Resource consent application – s92 request and s37 timeframe extension

Application number:	BUN60397498
Applicant:	Bentley Studios Limited
Proposed activity:	Construction of 81 residential dwellings and associated vehicular access, parking and landscape arrangements, non-compliances with residential noise levels and associated unit title subdivision.
Site address:	96 Beach Haven Road and 13 Cresta Avenue, Beach Haven

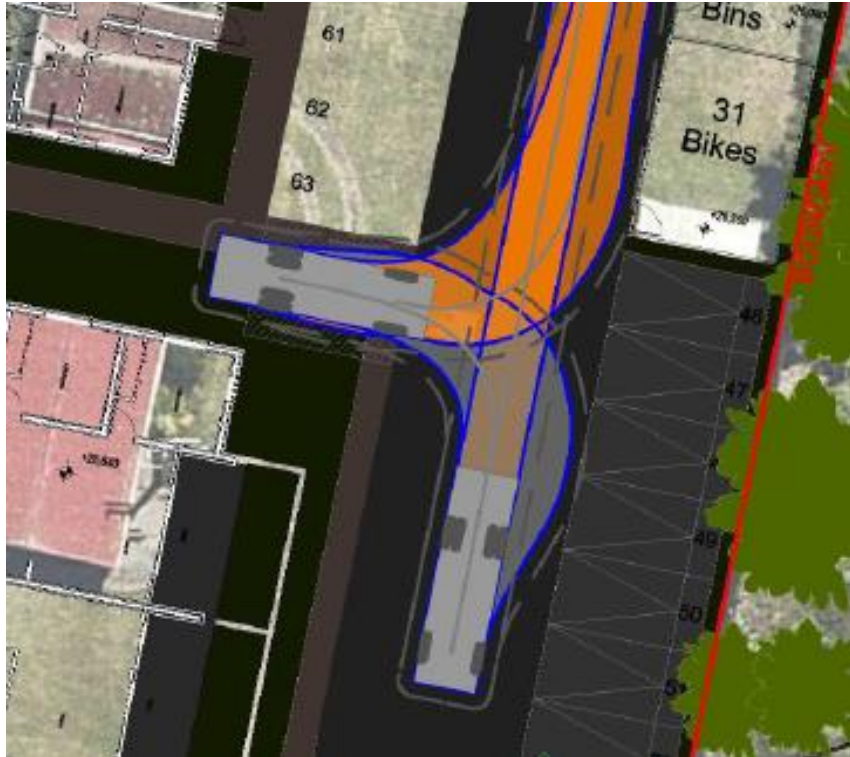
17. Based on the submitted vehicle tracking diagrams (see image below), it appears that the rubbish truck will require additional space for manoeuvring than shown on the landscape plan, which indicates that the rubbish truck will drive over the landscaped area / footpath. Please clarify / update the plans as necessary to address this.

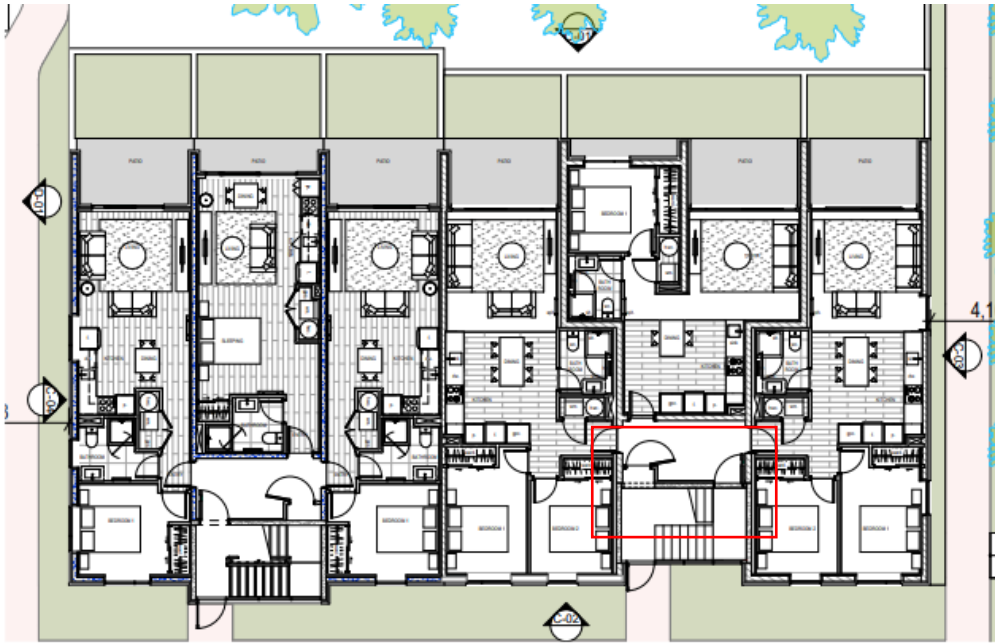
21. Please provided scaled cross-sections in the locations shown below to demonstrate:
 - a. The height of the boundary wall and fence relative to the outdoor living spaces and the natural ground level of the adjoining sites; and

- b. The position of the retaining wall, fence and planting (on top, in front of or behind the retaining wall).

Please clearly label the retaining wall, fence and planting and provide the dimensions. The vegetation should be shown at the growth height at five years. Accurate shape (height, width, density) plants similar to what species are being proposed should be illustrated in the sections / details.

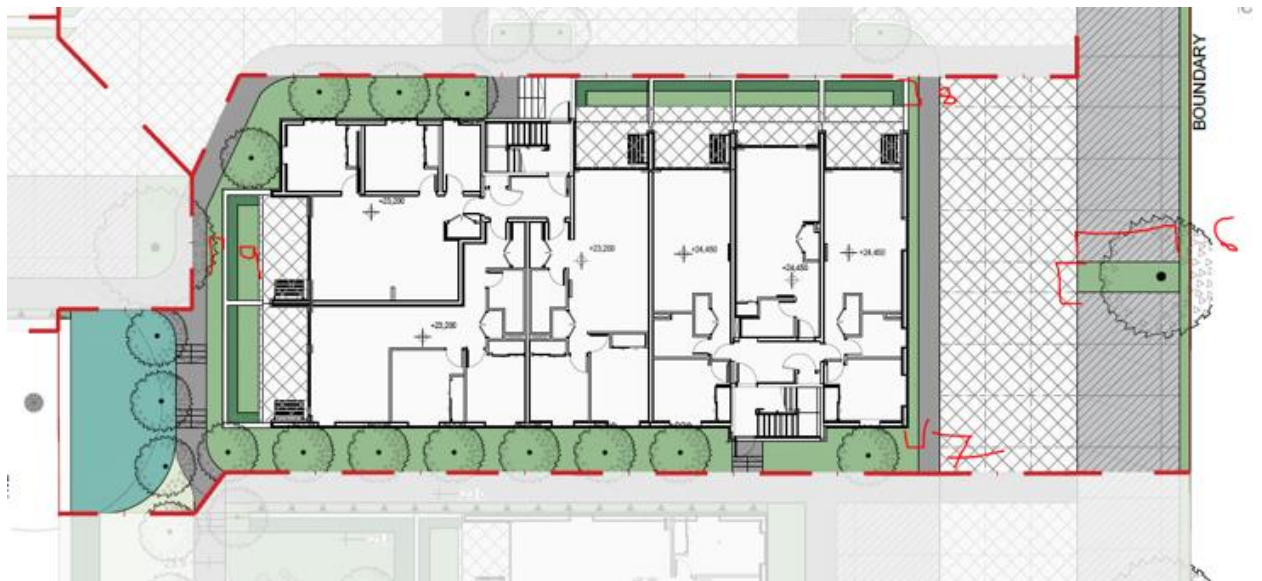
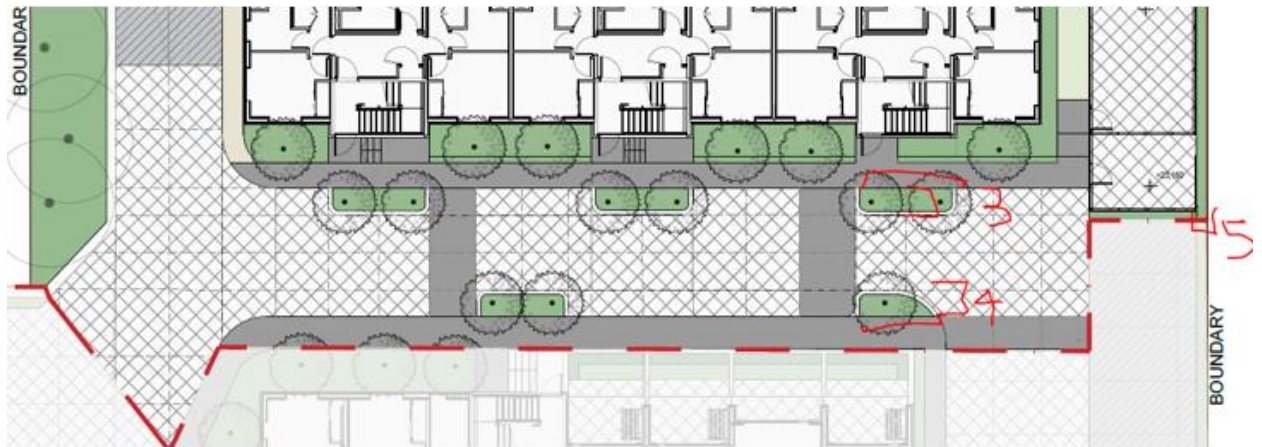
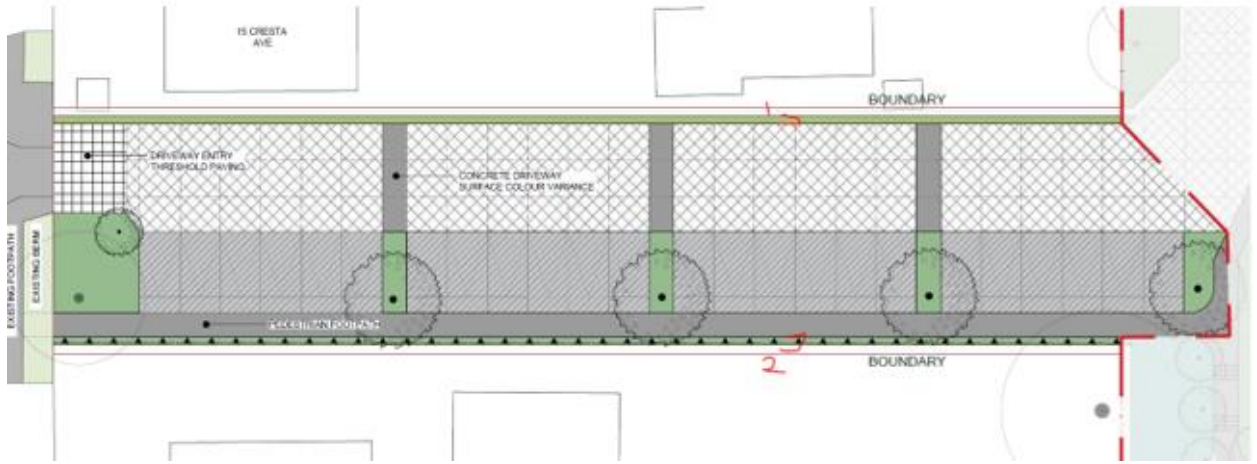
26. Please provide a set of cross sections through the locations in the image below. This is requested to understand the relationship of the pedestrian paths, retaining walls / fences (levels) and the proposed planting. The vegetation should be shown at the growth height at five years. Accurate shape (height, width, density) plants similar to what species are being proposed should be illustrated in the sections/details).

27. Please provide the dimensions of the spaces in the images below in terms of the extent of medium / soil provided for the planting e.g., exclude space required for hard structures such as retaining walls and fences where relevant.
